DOCUMENT 00 90 00
ADDENDUM

ADDENDUM NO. [2] **Date: September 23, 2021**

RE: LA FARGE SCHOOL DISTRICT
ADDITION AND RENOVATION
301 W. ADAMS STREET
LA FARGE, WI 54639
HSR Project 19041-1

FROM: HSR Associates, Inc
100 Milwaukee Street
La Crosse, WI 54603
(608) 784-1830

P100

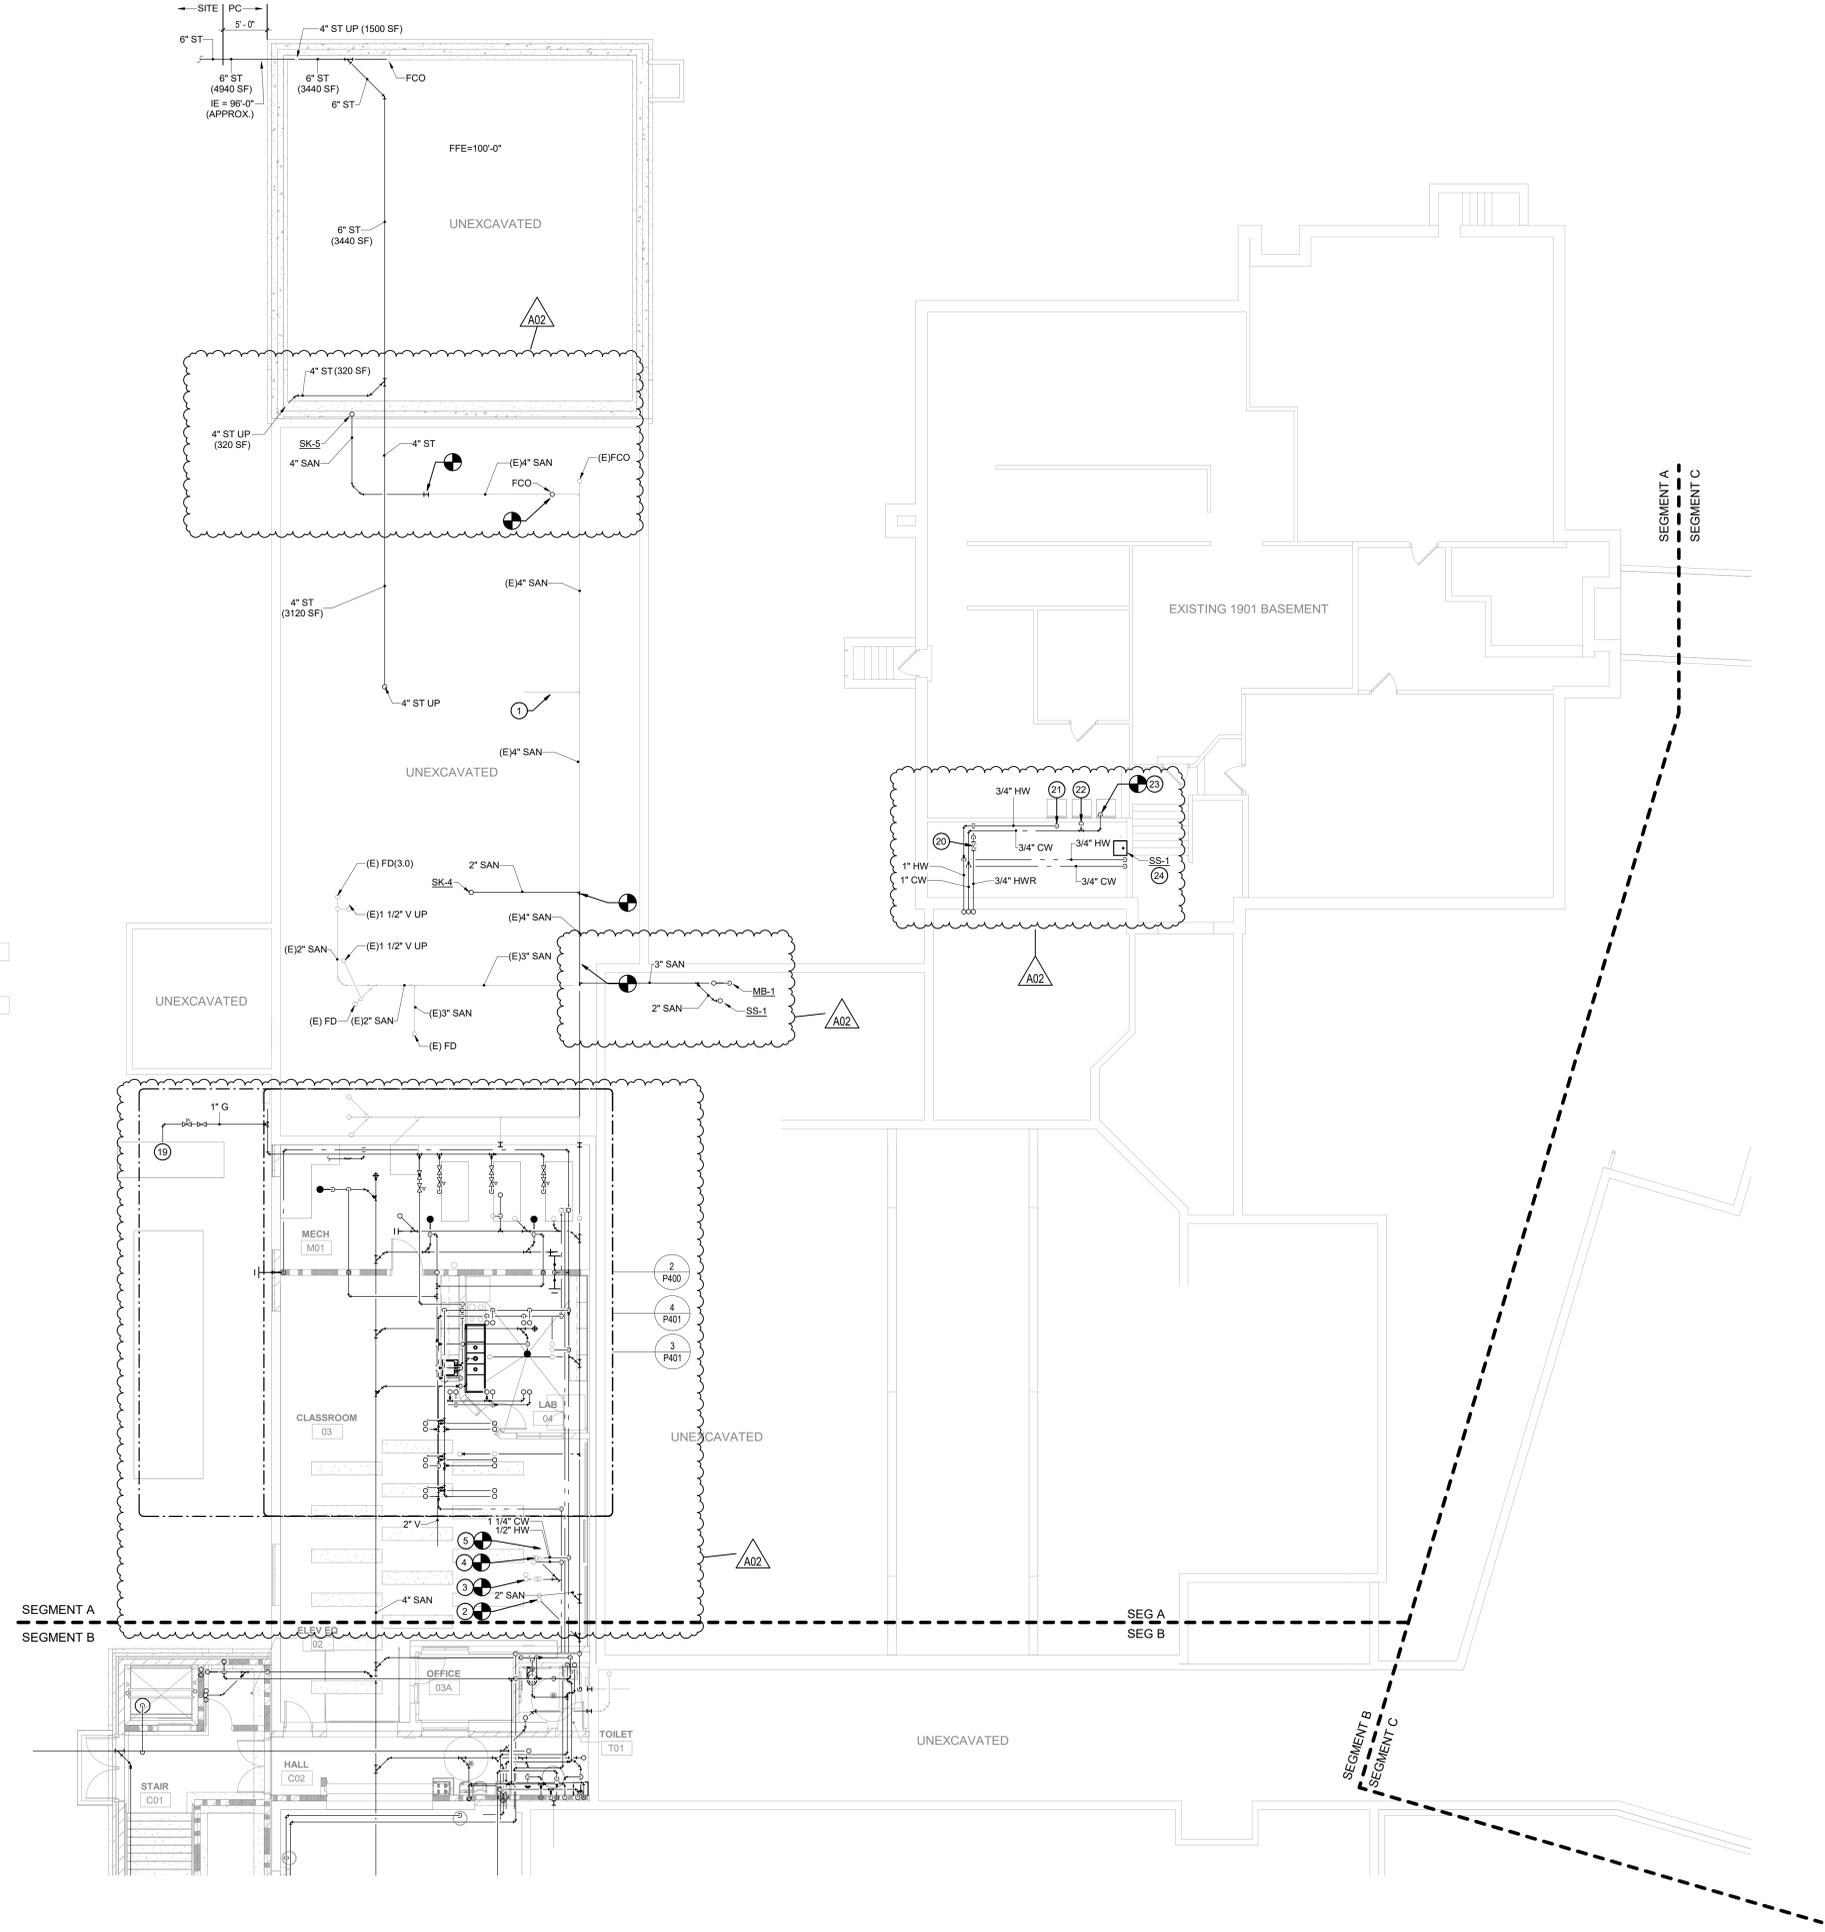
14. Sheet P100 LOWER LEVEL PLUMBING PLAN –SEG A 30 X 42 attached hereto
 - a. Revisions clouded on drawing.
 - b. New work scope added/clarified.
 - c. Keynotes added.

P101

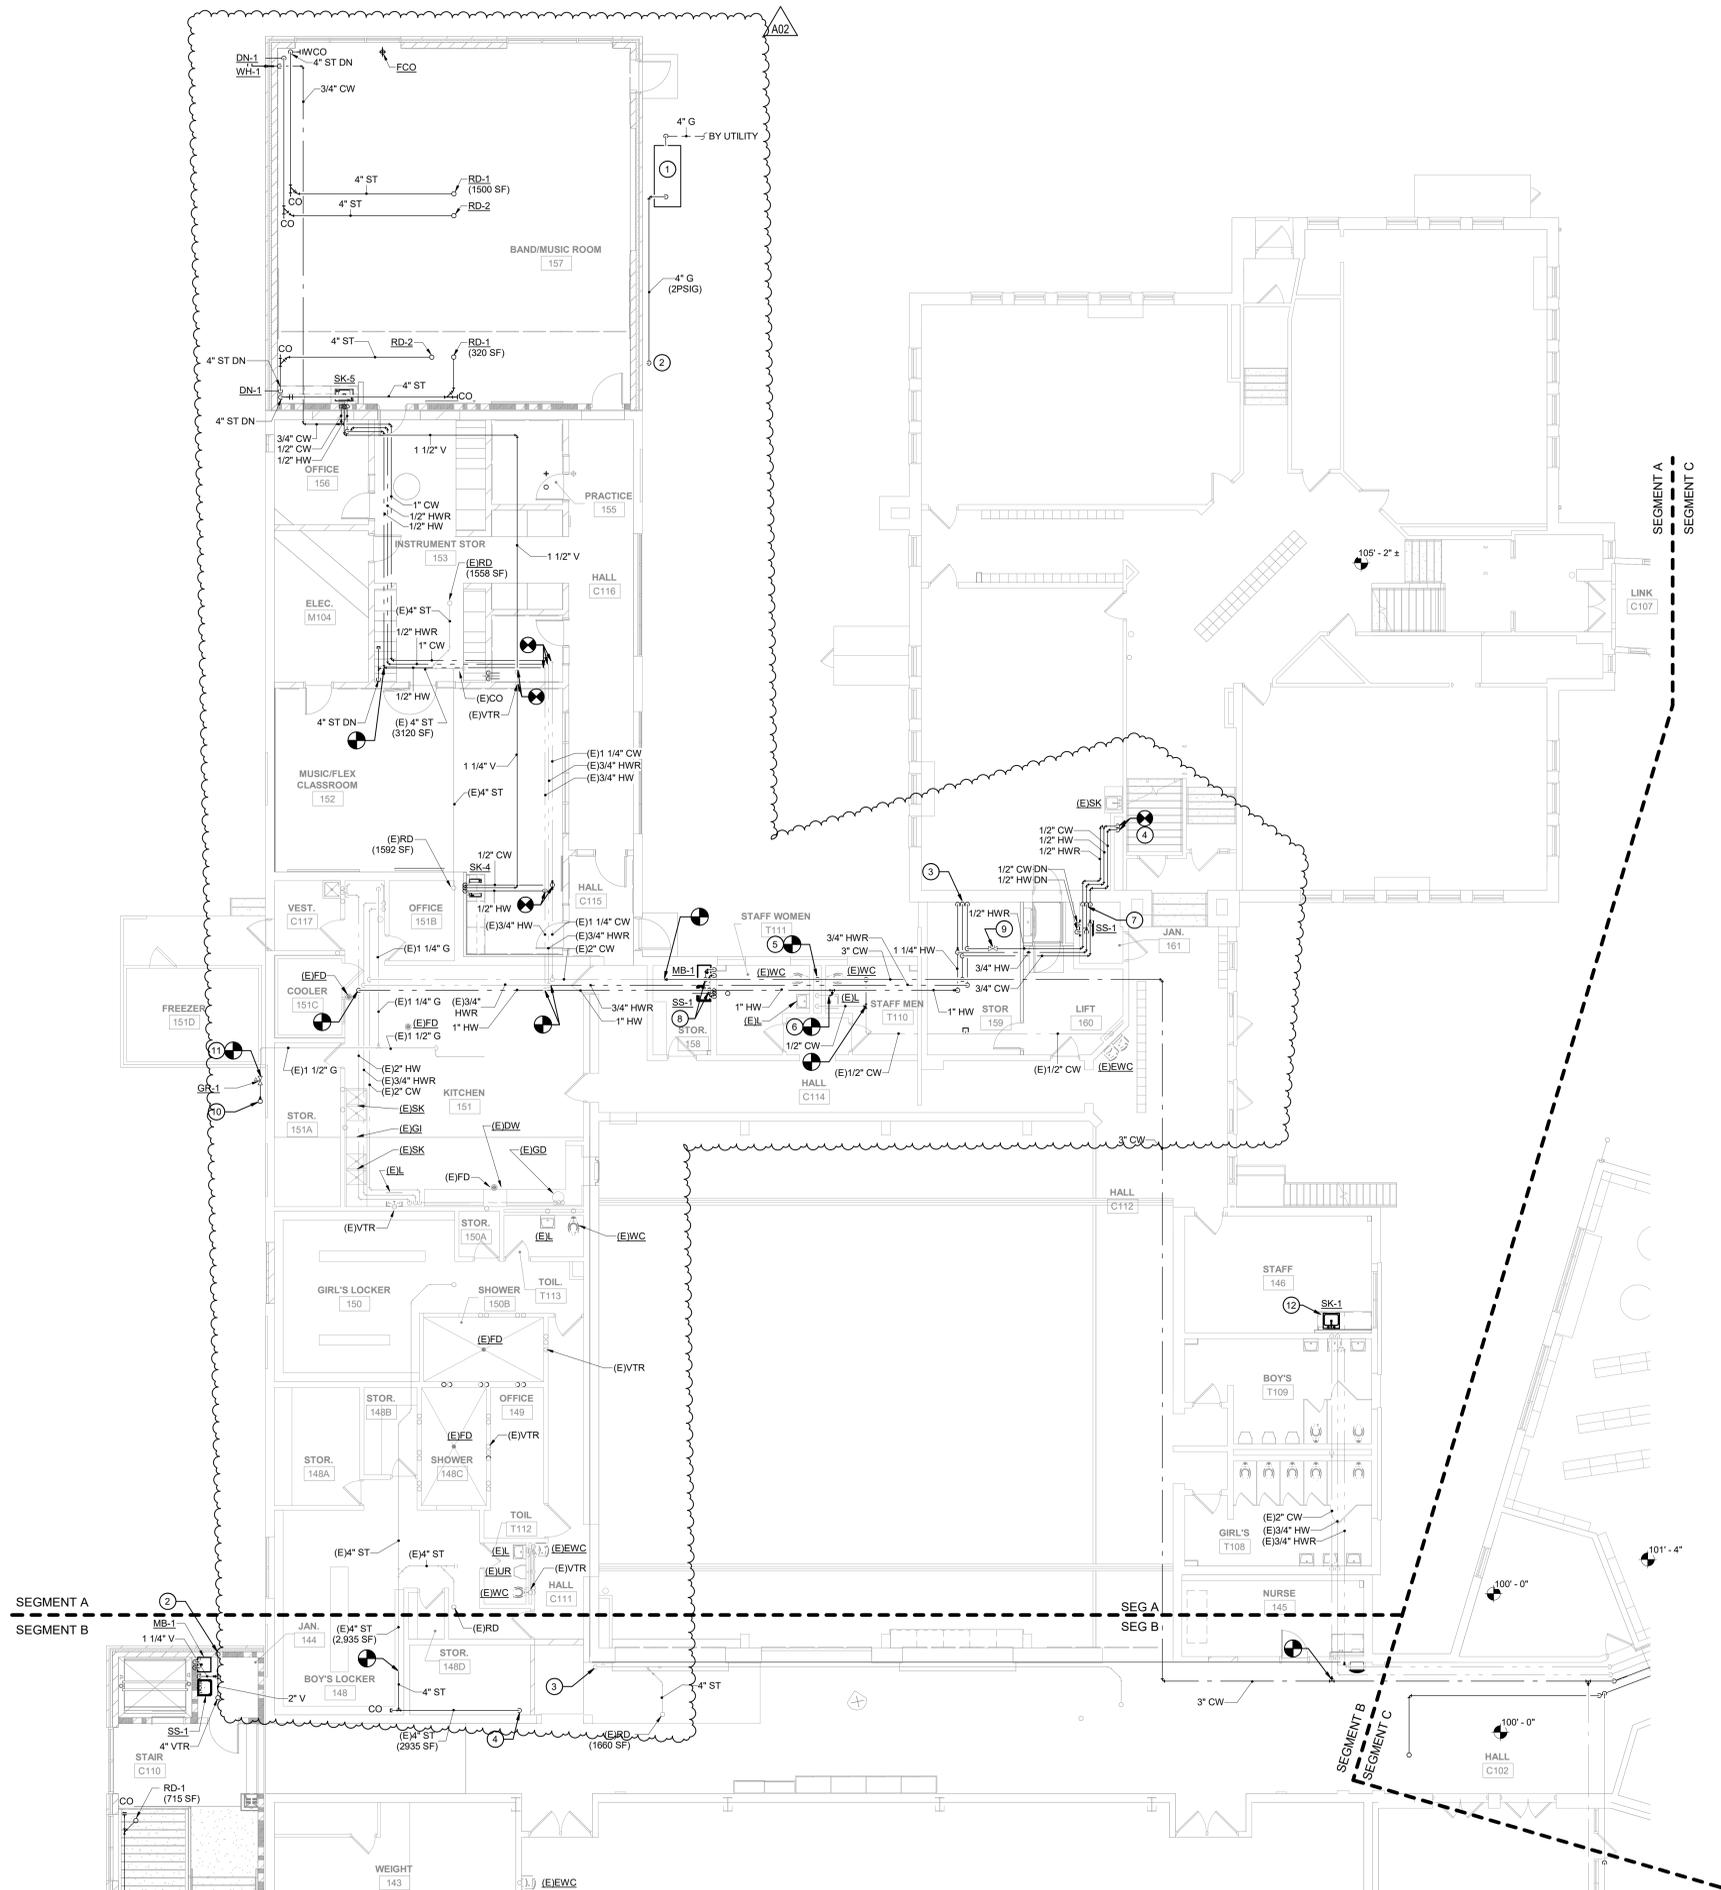
15. Sheet P101 LOWER LEVEL PLUMBING PLAN – SEG B 30 X 42 attached hereto
 - a. Revisions clouded on drawing.
 - b. New work scope added/clarified.
 - c. Keynotes added.

P104

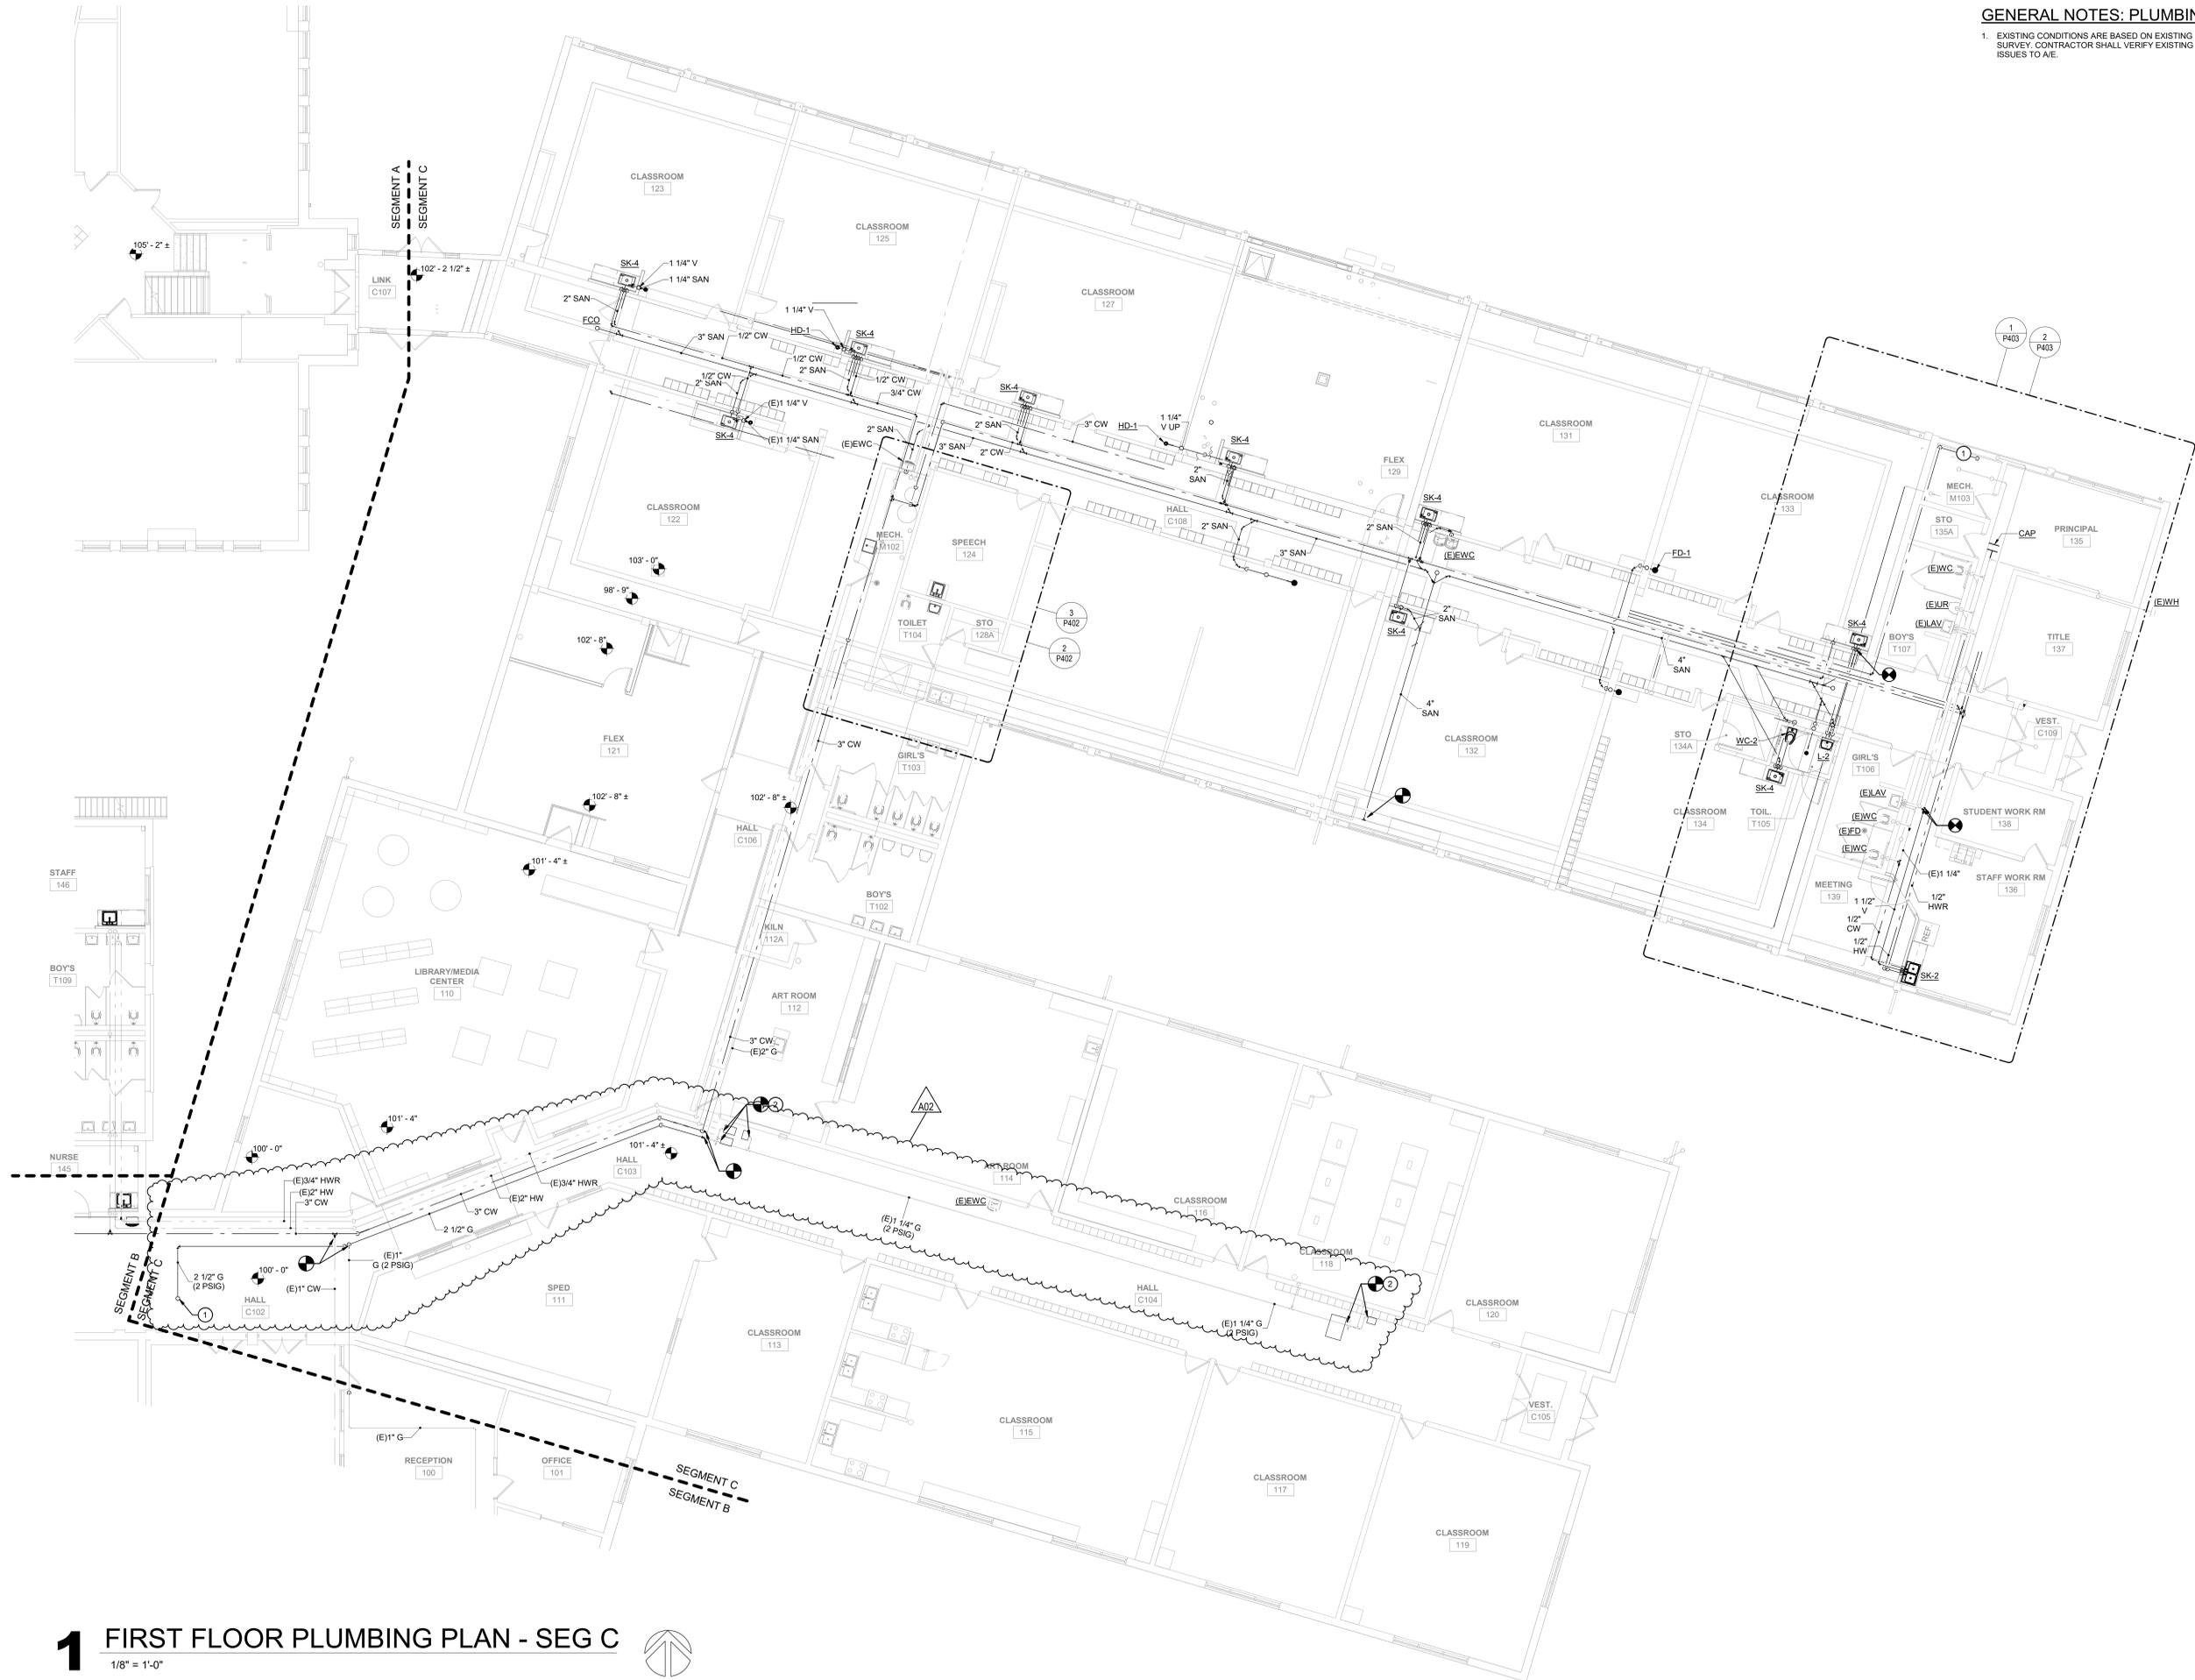
17. Sheet P104 FIRST FLOOR PLUMBING PLAN – SEG C 30 X 42 attached hereto
 - a. Revisions clouded on drawing.
 - b. New work scope added/clarified.
18. Sheet P400 PLUMBING ENLARGED PLANS 30 X 42 attached hereto
